Final Panel Report

Melton Planning Scheme Amendment C162

Mt Atkinson and Tarneit Plains Precinct Structure Plan

9 December 2016

Figure 3 Precinct features, including the location of buffers and easements (exhibited version)

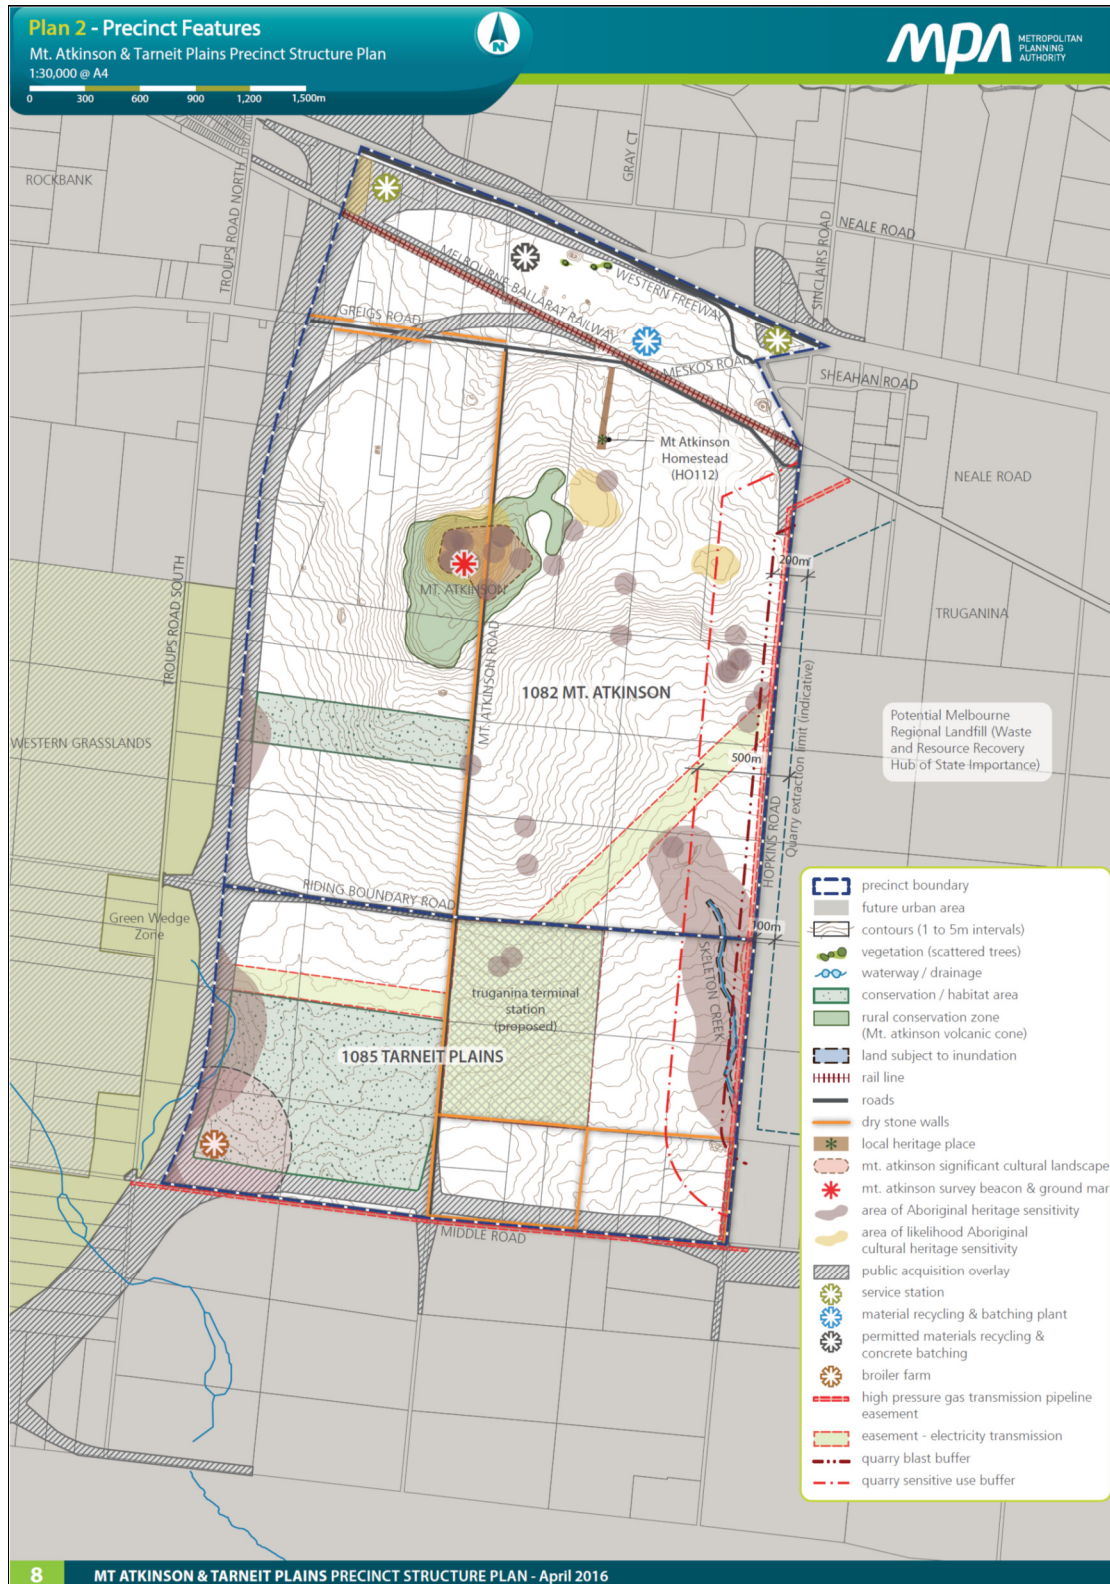
The exhibited PSP identifies a 'Quarry Blast Buffer' (QBB) extending 200 metres from the approved extraction limit under the quarry Works Authority, and a 'Quarry Sensitive Use Buffer' (QSUB) extending 500 metres from the approved extraction limit⁷. These buffers are shown in Plan 2 in the PSP (refer to Figure 3 above).

Figure 7 above, prepared by Landfill Operations, identifies a 1 kilometre odour buffer for the entire length of the PSP. The Panel considers that the odour and amenity buffer is only required in the northern portion of the PSP, to ensure a 1 kilometre separation distance to residential areas, mixed use areas, the town centre and recreational open space. The Panel does not consider that the odour and amenity buffer is required where industrial uses will locate, because industrial uses are less odour sensitive than the mixed use and retail uses proposed in the northern section of the PSP. The odour and amenity buffer can terminate at the high voltage electricity transmission easement.

- a) Amend Plan 2 of the Mt Atkinson and Tarneit Plains Precinct Structure Plan to show a 'Landfill Odour and Amenity Buffer' of 1 kilometre (measured from the edge of the nearest proposed landfill cell), north of the high voltage electricity transmission easement.
- b) Determine (in consultation with the Environment Protection Authority and Landfill Operations) whether any additional uses should be prohibited or permit required in the Landfill Odour and Amenity Buffer, beyond those prohibited or permit required in the Quarry Sensitive Use Buffer, and amend the Urban Growth Zone Schedule 9 accordingly.
- c) Insert the following Clause in the Urban Growth Zone Schedule 9:

Figure 8 Plan 12 (Utilities) from the PSP

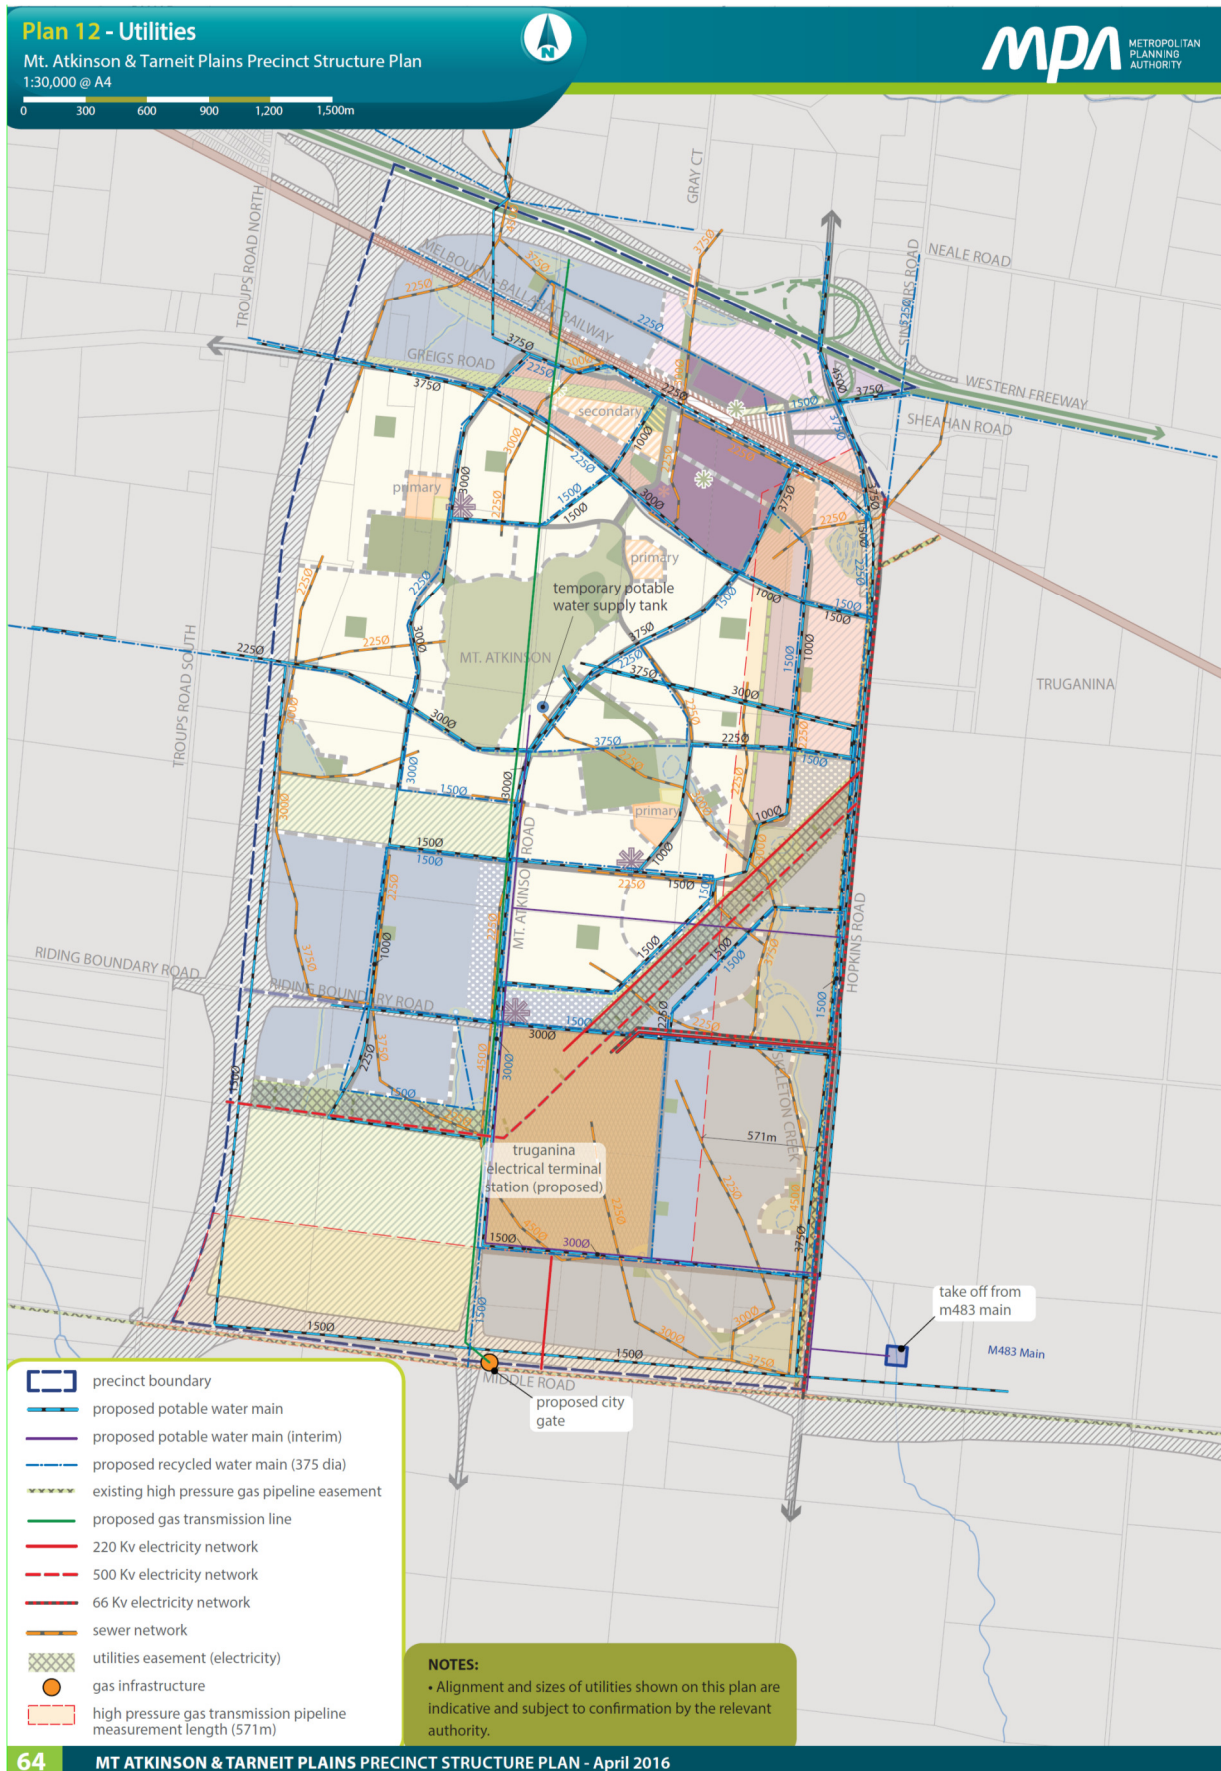
The pipeline easements, along with their measurement length¹², are identified on Plan 12 (Utilities) of the PSP (reproduced as Figure 4 below).

APA submitted that retail premises are commonly identified as a sensitive use, as they include a wide range of uses involving persons who have different ability to manage and respond to risk events. APA indicated that including retail as a sensitive use was 'standard' within the planning system, and submitted that the Panel for the Donnybrook/Woodstock PSP had included retail as a sensitive use. The VPA did not agree. It submitted that retail, particularly large format retail, does not generally involve large congregations of people, and restricting otherwise as of right uses in a business/large format retail area would be counterproductive to facilitating development. Mt Atkinson Holdings (Submission 22) supported the VPA's position.

Figure 9 Proposed relocated IT05

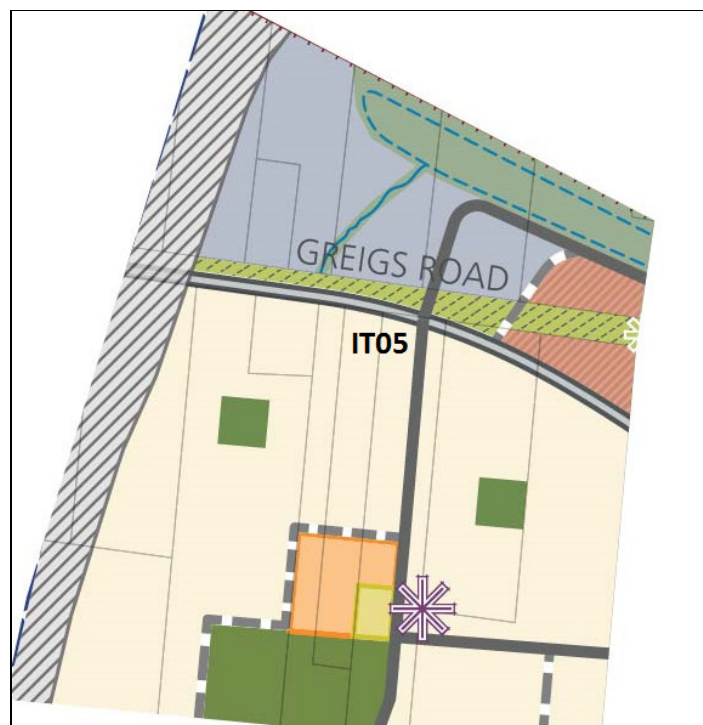
Intersection IT05 is identified on Plan 13 – Precinct Infrastructure Plan (page 68 of the PSP) at the intersection of Greigs Road and a proposed north-south connector street. Council submitted that intersection IT05 should be moved towards the north-west to maintain the road segment RD01 within the existing 60 metre Greigs Road reserve and minimise land purchase requirements, as shown in Figure 9.

Council submitted that moving intersection IT05 to the north-west would avoid creating a small triangle of land between the proposed intersection to the south and the Greigs Road reserve to the north that would prove difficult to develop. It would additionally assist to straighten the proposed north-south connector street and minimise the land purchase requirements for the RD01 road segment.

The Panel concludes that intersection IT05 should be moved to the location as proposed by Council and shown in Figure 9 of this report.

Figure 10 Council preferred primary arterial cross section

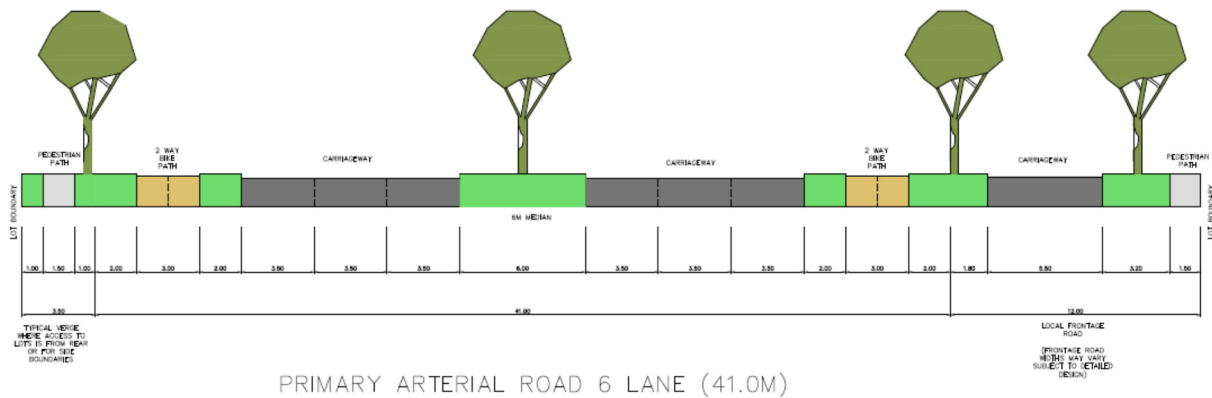
Council proposed a modified cross section for primary arterial roads which separates the two way bicycle path and the pedestrian path. The Council proposal is as shown in Figure 8 of Mr Pelosi's evidence and reproduced as Figure 10 below.

The VPA agreed with Council's proposal.

30. Modify Road Section 7 primary arterial 6 lane (page 99 of the exhibited Precinct Structure Plan) to separate the two way bicycle path and the pedestrian path as shown in Figure 10 of this report.

Figure 11 Council preferred secondary arterial cross sections

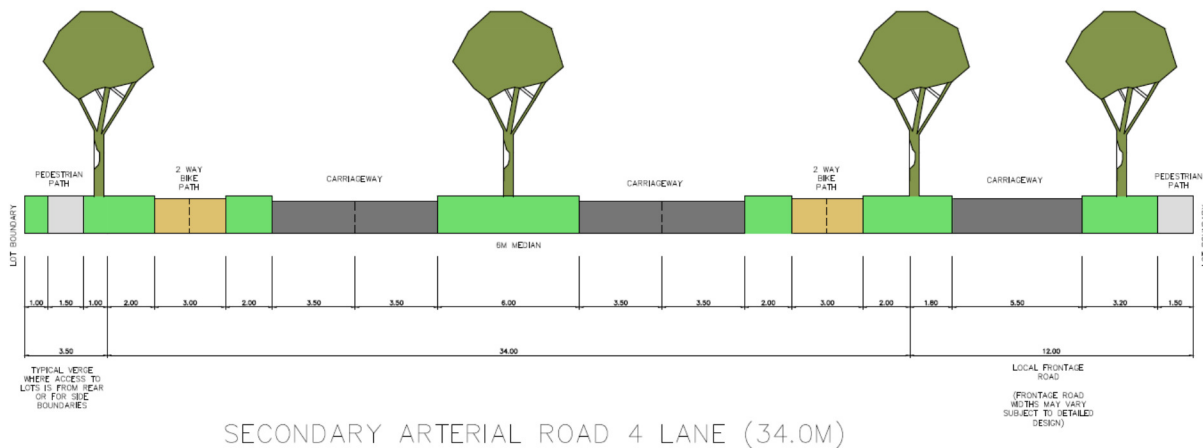
Council did not support on road bicycle paths on secondary arterial roads. Council's preference was to provide two-way off-road bicycle paths on either side of the road reserve (in addition to a pedestrian path on each side of the road). Council provided an alternative secondary arterial road cross-section, which is shown at Figure 9 in Mr Pelosi's expert witness report (page 15), and reproduced as Figure 11 in this report. Council submitted that *"this is caveated by agreement with the VPA that the on-road bike paths forming the western end of Greigs Road in the Rockbank PSP need to be continued for that road formation."* The secondary arterials therefore still in dispute with regard to on-road bicycle lanes are Riding Boundary Road and Mt Atkinson Road.

Mr Pelosi gave evidence that the VPA proposal to have on-road bicycle paths on secondary arterials represents an inconsistency in the treatment of cyclists with an undesirable practical consequence. He gave evidence that this means that cyclists would experience a reduction in the level of protection when travelling from a fully separated off-road bicycle facility on a connector street to a more exposed on-road facility on a secondary arterial road and finally back to full protection in the off-road bicycle path context found on primary arterial roads.

Figure 12 94- 118 Greigs Road

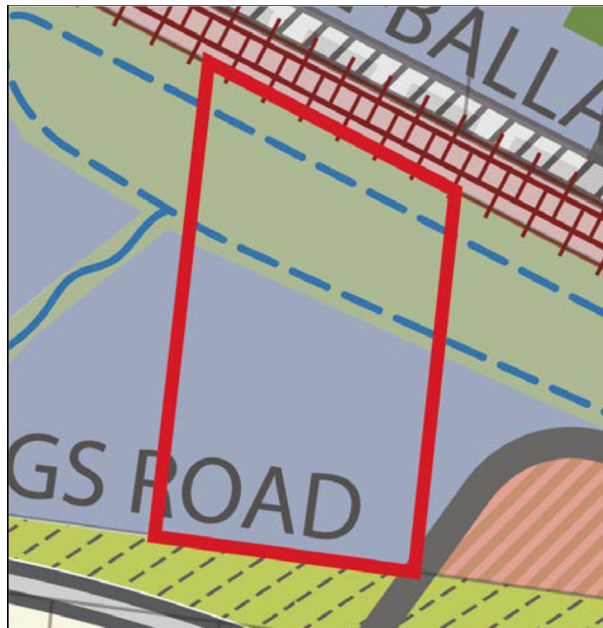
The issue is what land use designation should be applied to 94-118 Greigs Road as shown at Figure 12.

The PSP designates the southern area of this property as ‘*industrial*’ and the northern area as ‘*service open space (drainage)*’ (WI-04 on Plan 11- Integrated Water Management).

Figure 15 1789 Western Highway

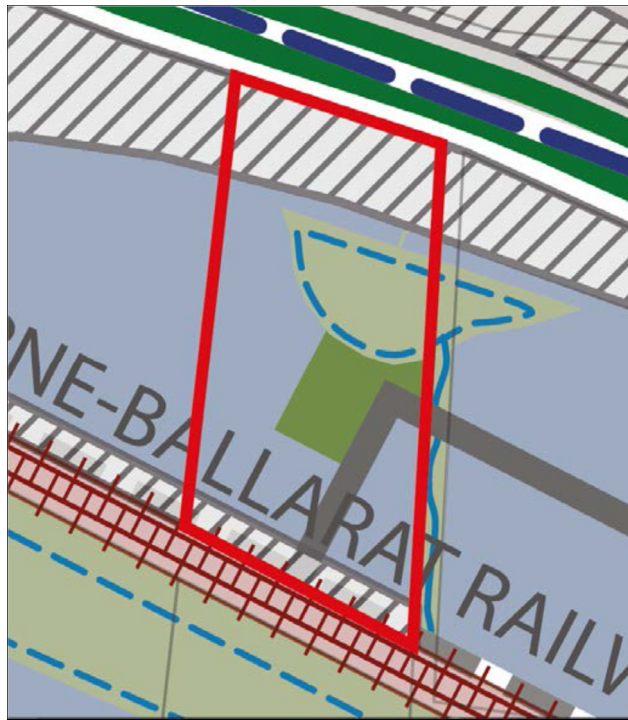
The issues relate to accessing this property shown at Figure 15 and the designation of various land uses.

- the property has been landlocked for some time with no access point to the Western Highway since the creation of the service centre
- the north south portion of the connector street on the property should be aligned with the existing Hilton Road reserve east of the eastern boundary of his property
- the proposed drainage basin should be relocated to:
 - adjoin the Public Acquisition Overlay area to the north
 - be partly positioned on the adjoining property to the east
 - better follow the natural ground levels
- the open space area on the land is poorly located and not appropriate in an industrially zoned area.

Clarification was also sought about the timeframe for the construction of the east-west connector road to the south of the property and inclusion of the road in the ICP.

The VPA responded as follows:

Figure 16 1813-1839 Western Highway

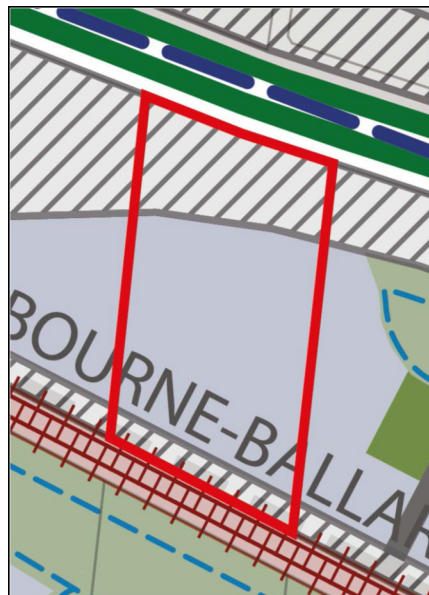
The issue is the lack of access to this property shown on Figure 16.

Similar to Mr Cauchi's situation, Mr Vella's land has been landlocked for some time with no access point to the Western Highway since the creation of the service centre. He sought clarification of the timeframe for the construction of the east-west connector road to the south of his property) and inclusion of the road in the ICP

Figure 18 343-357 Greigs Road

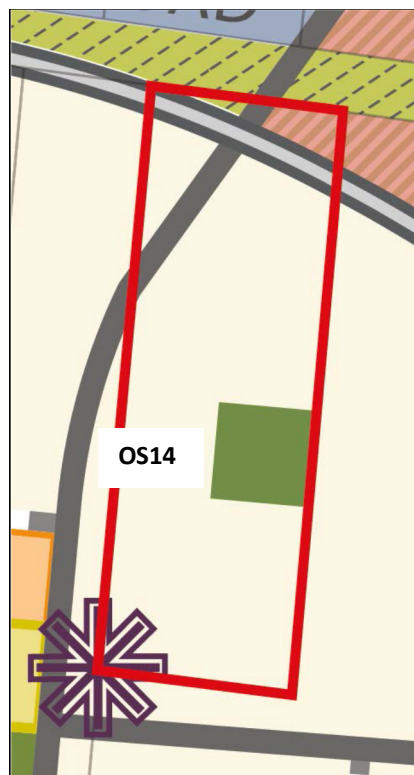
Mr Antoniou raised issues in relation to open space OS14 and the location of IT05 in relation to his property shown at Figure 18.

Mr Antoniou submitted that local park OS14 is not centrally located within the relevant catchment area. He submitted that *“OS14 doesn't optimise accessibility to open space and heavily burdens Property 31”*. He proposed the park be relocated further east on the neighbouring property (32). He submitted that this would provide a better distribution of open space and Property 32 forms part of a larger development site, ameliorating the impacts on Net Developable Area.

The VPA responded that local park OS14 is located to give consideration to the open space provision of the Mt Atkinson Volcanic Reserve. The VPA submitted that the volcanic reserve will provide active open space and a local park facility in the northern part of the reserve, and moving the park to the south east would result in an overlap of local park provision between OS14 and the Mount Atkinson Volcanic Cone Reserve.
